**MACEDONIA PLANNING COMMISSION
MEETING AGENDA
MARCH 21, 2022**

**MACEDONIA PLANNING COMMISSION
FEBRUARY 14, 2022
MEETING MINUTES**

Re: Plan Review Comments: Dominion – 9796 Shepard Rd., Station Replacement

FRONT ELEVATION

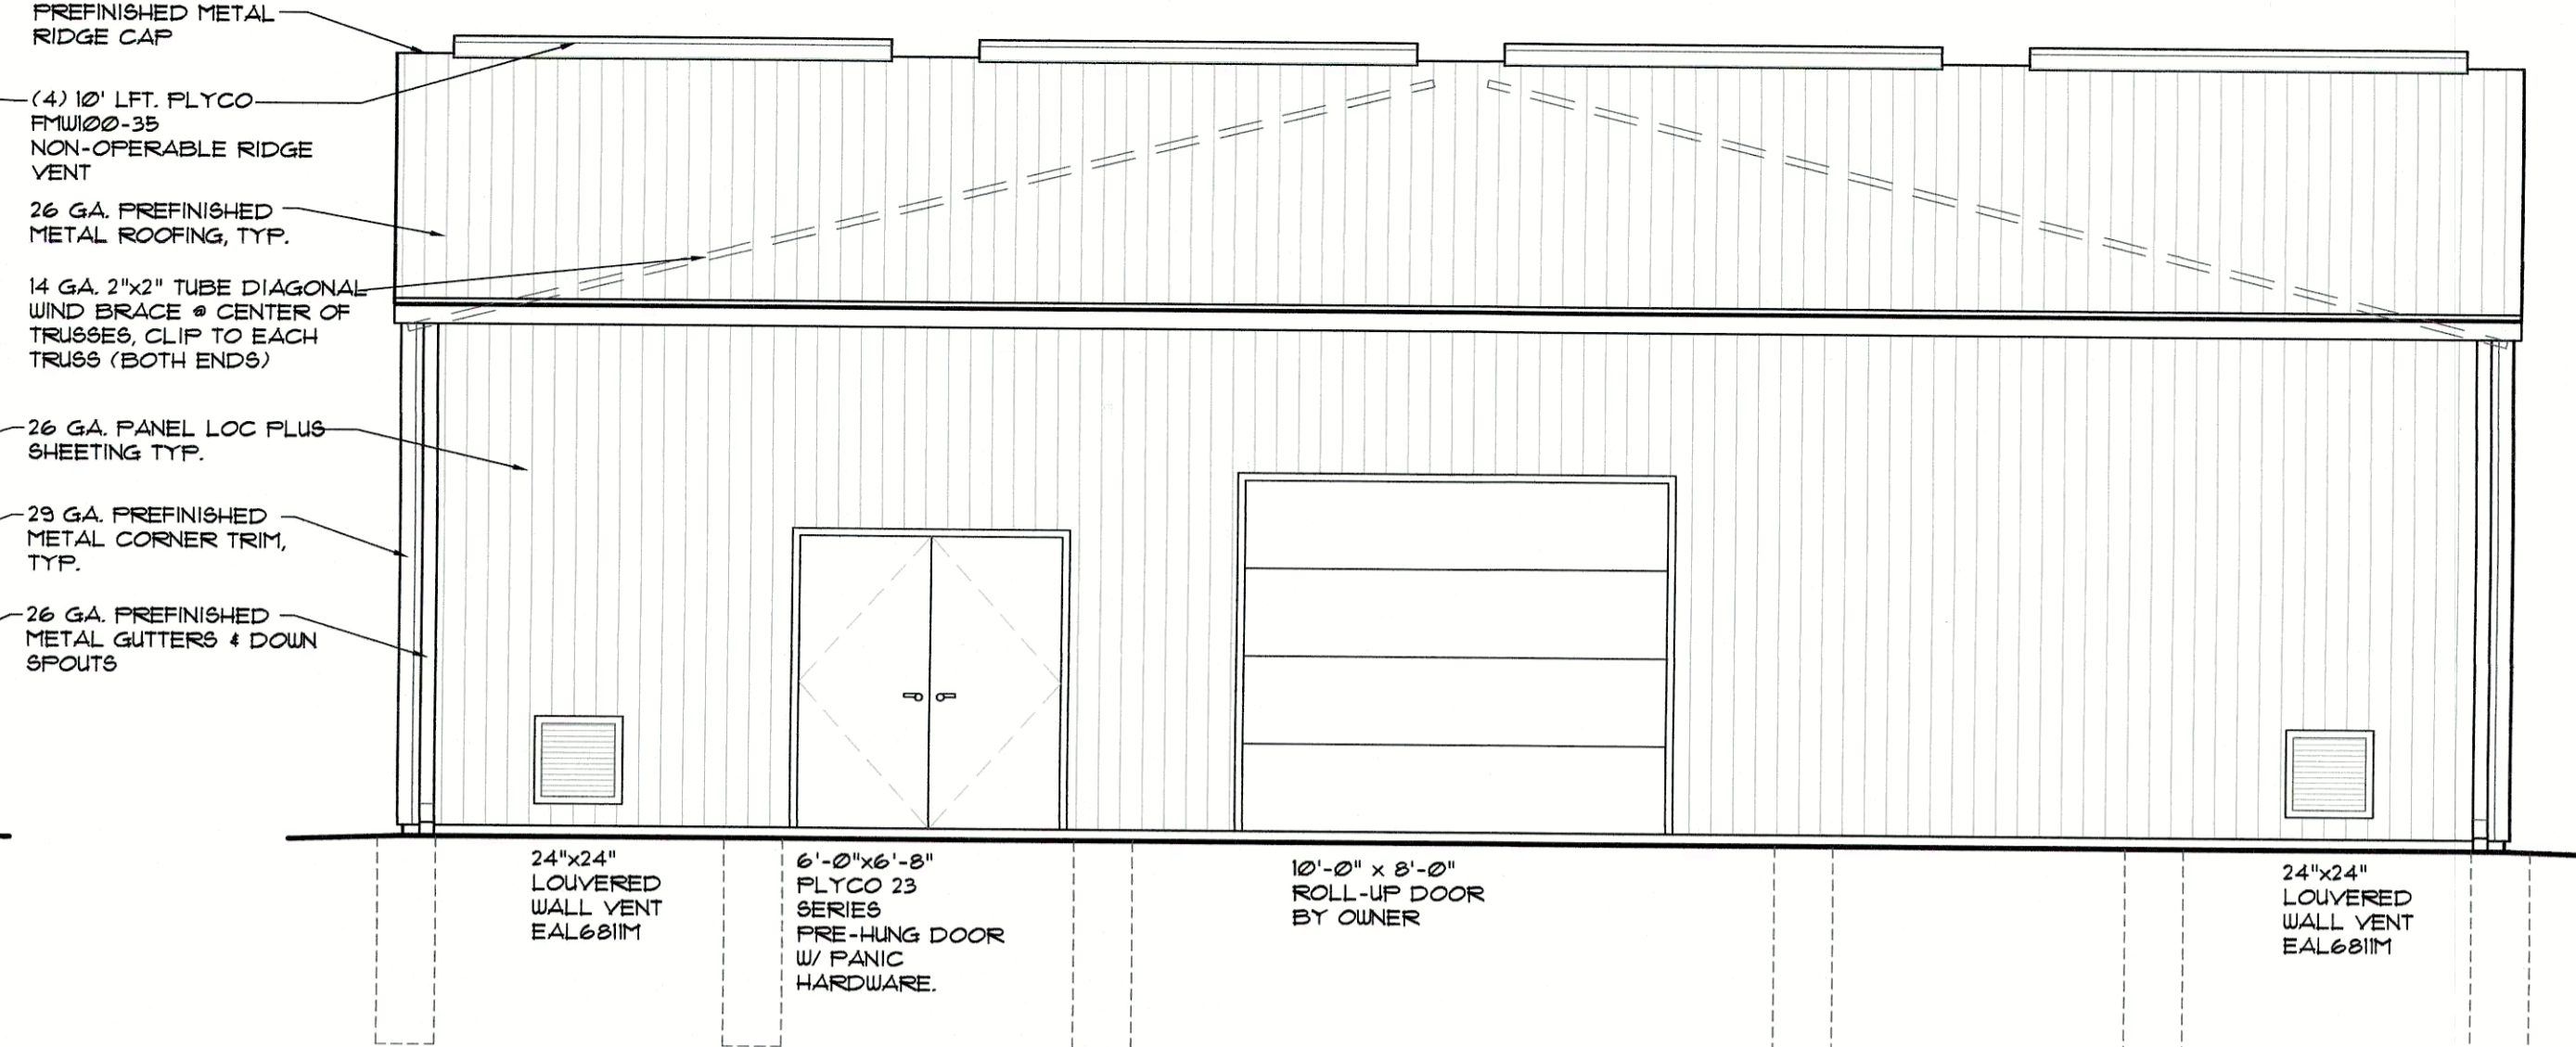
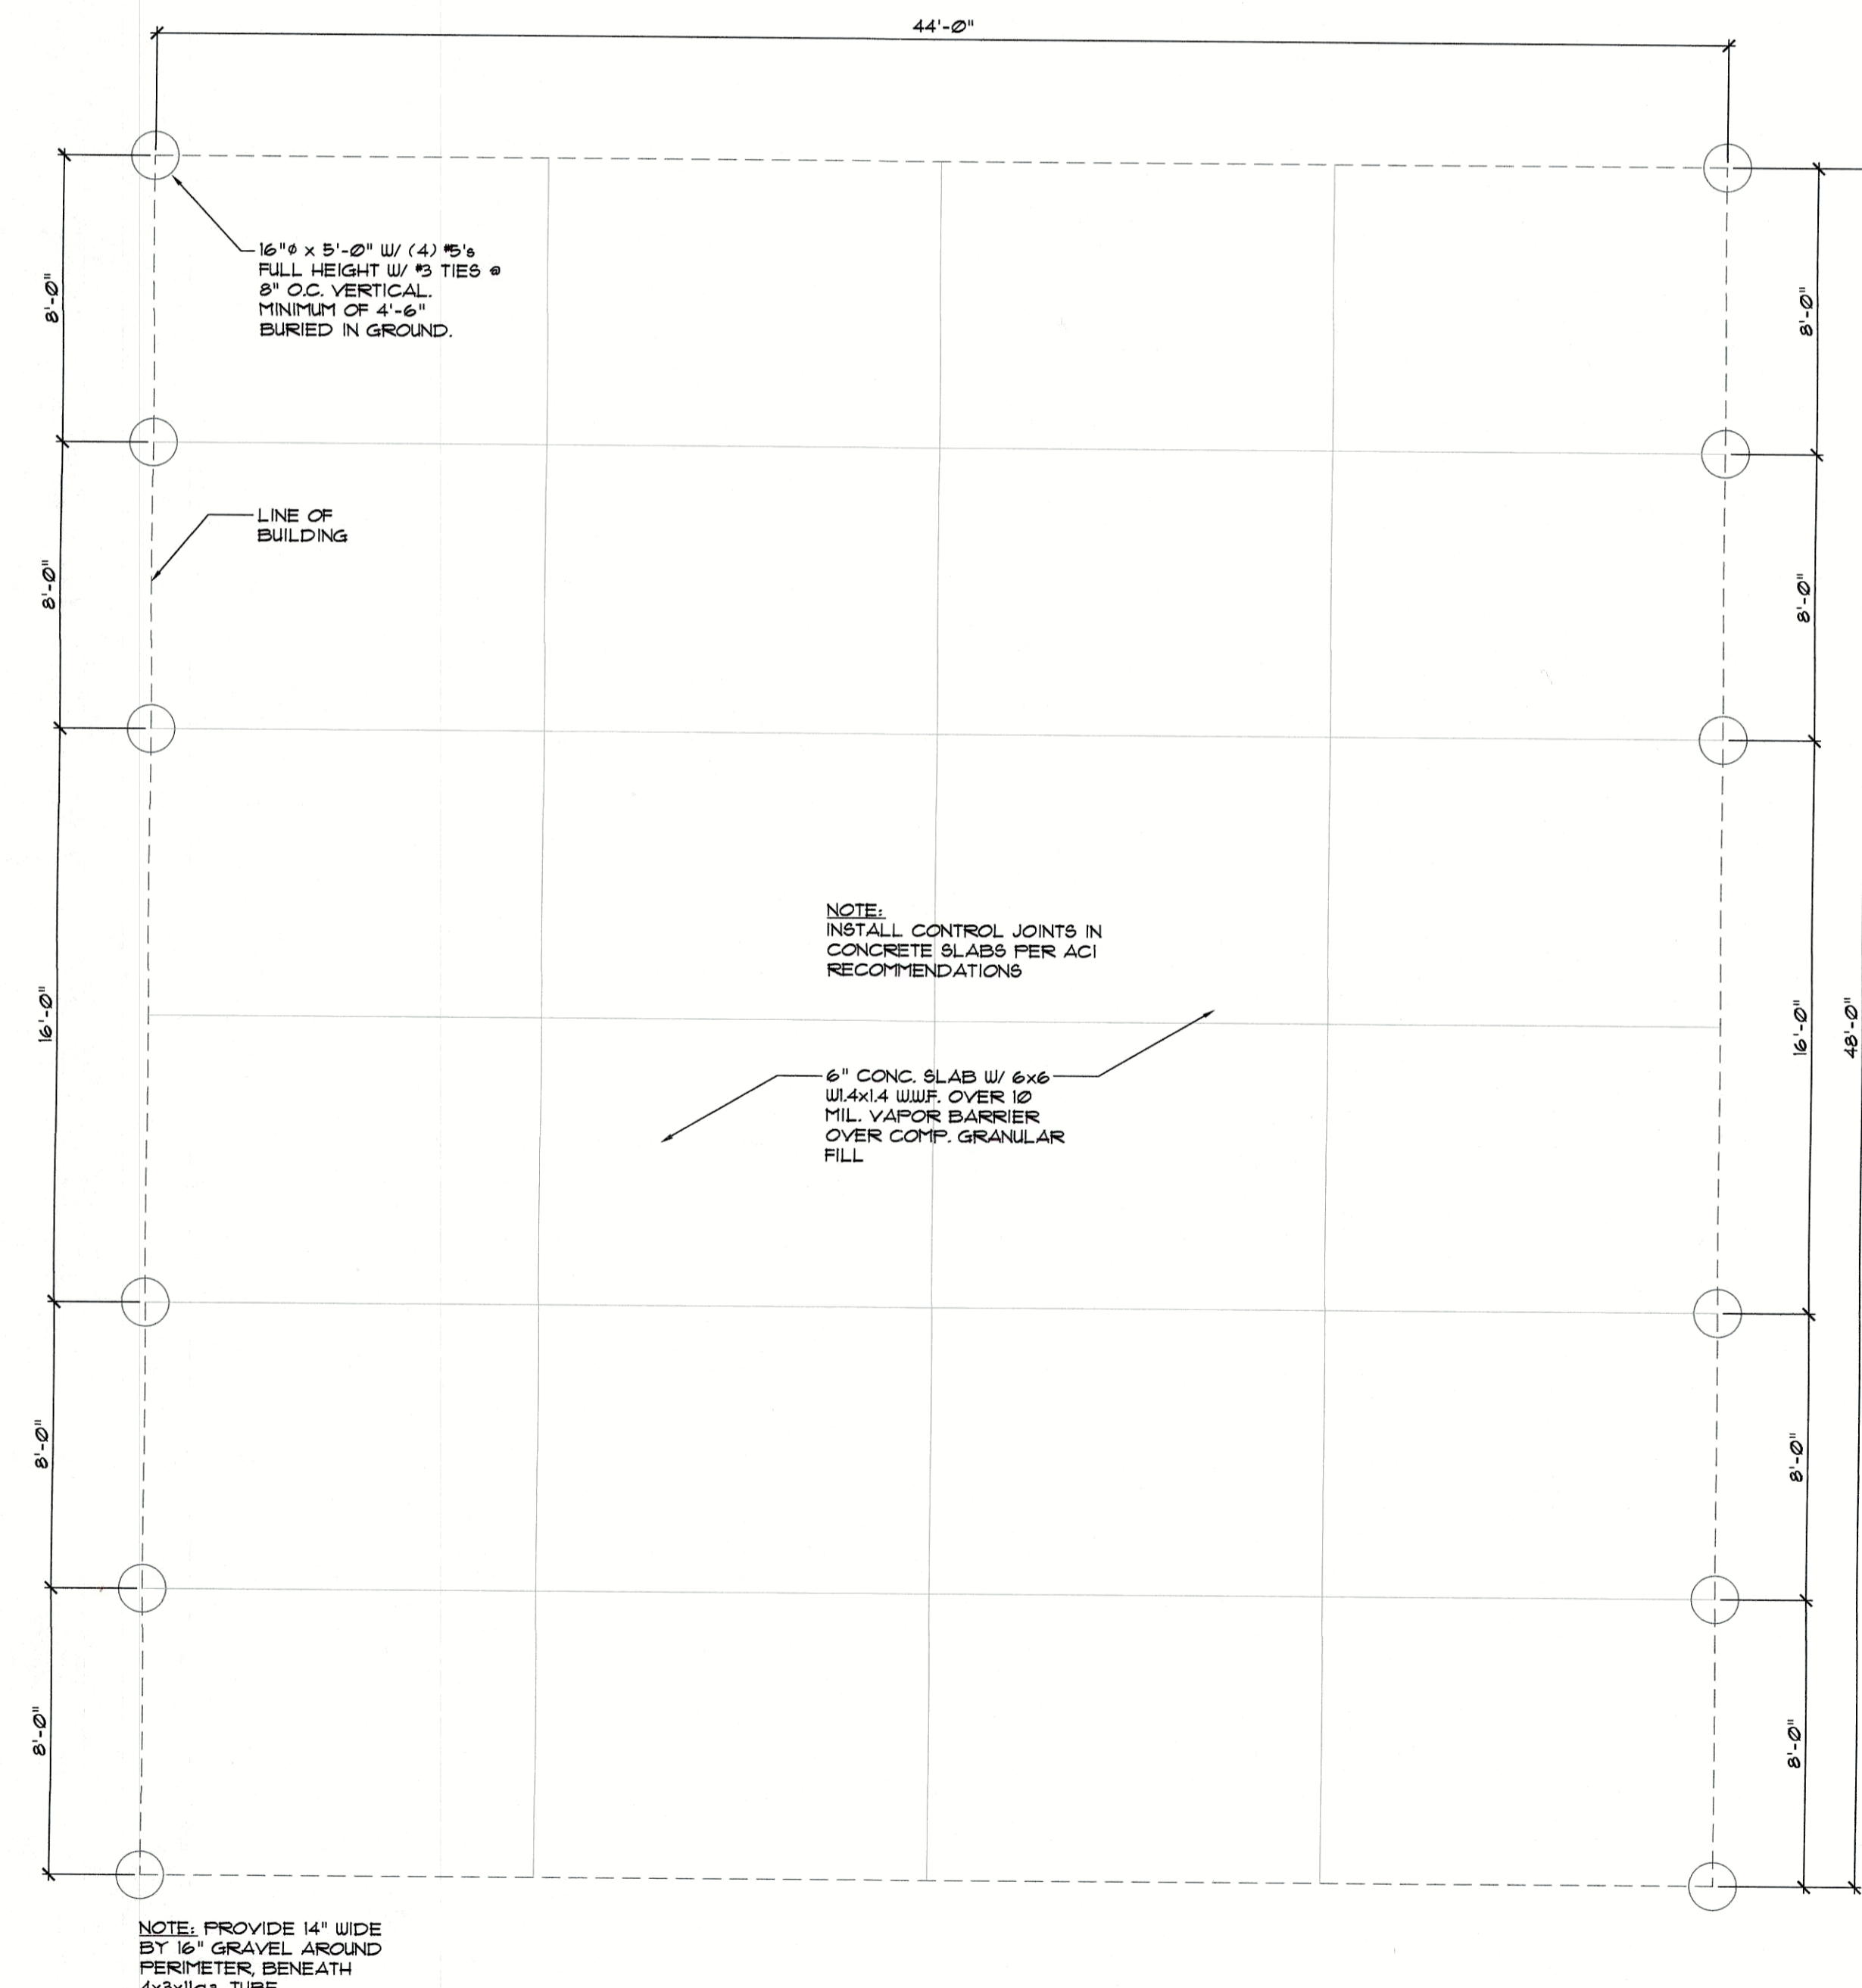
1. The design of the proposed buildings are "inappropriate" and "generally unacceptable" which includes pre-engineered metal buildings (e.g. "pole buildings"). Please see 1172.02 (a)(10)B. Sheet metal is not permitted except as rain gutter/downspouts. Please see 1172.02 (a)(10)E. Materials shall be compatible and harmonious with and not in stark contrast to the materials used on adjacent structures. Please see 1172.02(a)(2) and (3). Material details will need to be added to coordinate with the neighboring building made of brick and limestone.

3. If the commission agrees, please verify the colors and quality of all materials proposed adhere to Macedonia Standards.
4. Drawings do not show any locations for HVAC. Please note, all mechanicals shall be screened. Please see 1172.02 (a)(4).
